02126 KIT

TO CONVERT FROM CONDUCTIVITY CONTROL TO TIMER ON SID 650's

CONVERT TO TIMER

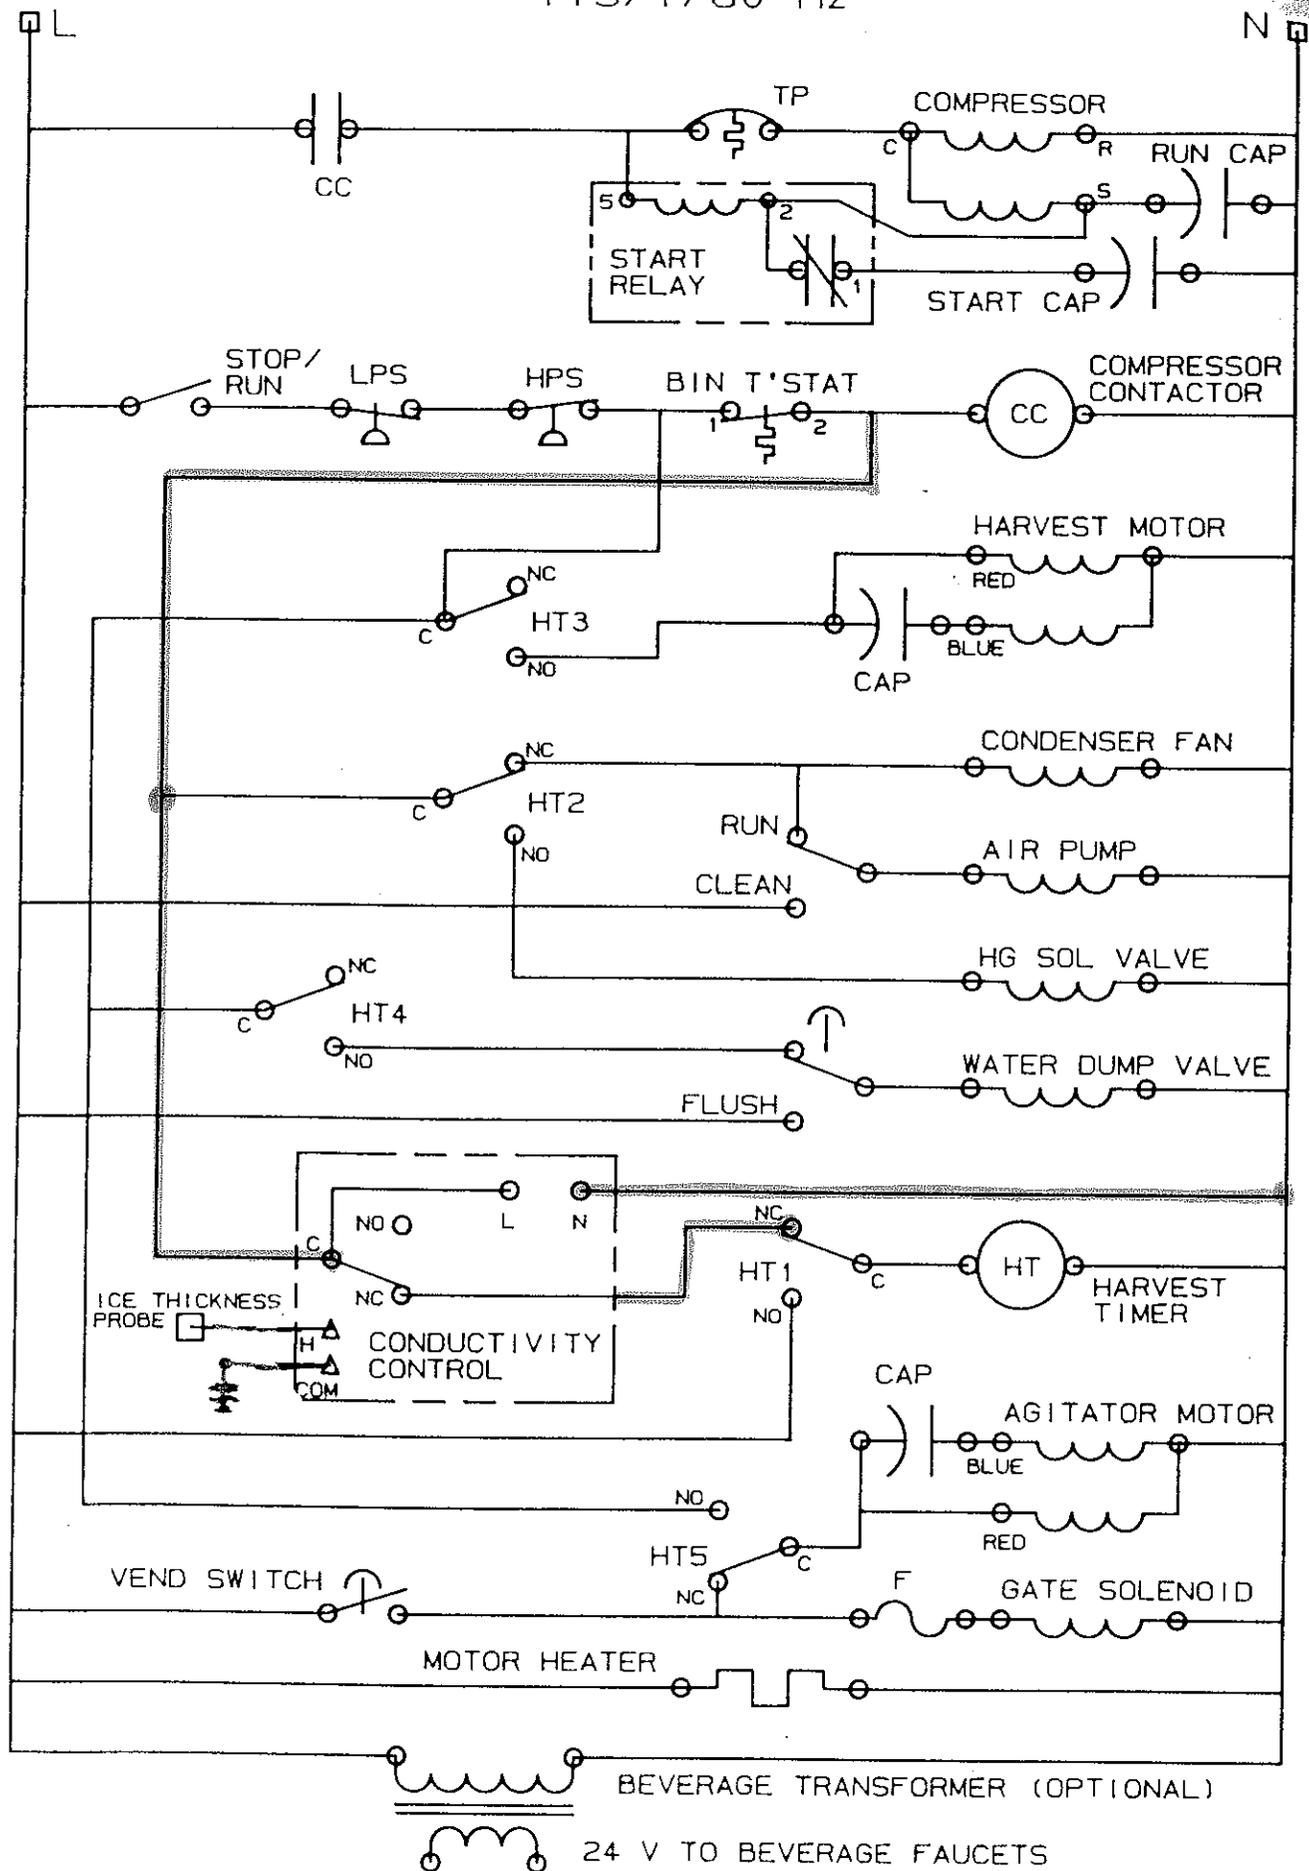
- 1) Disconnect wires from conductivity board and remove the board.
- 2) Install new timer (10 min 44 second cycle).
- 3) Connect the pink wire from the 5 cam timer (1st cam N.C. position), to #1 on the new timer.
- 4) Connect the red wires from the bin stat and the 2nd cam (common), to #2 on the new timer.
- 5) Connect the white wire from the neutral side of the terminal board to #3 on the new timer.
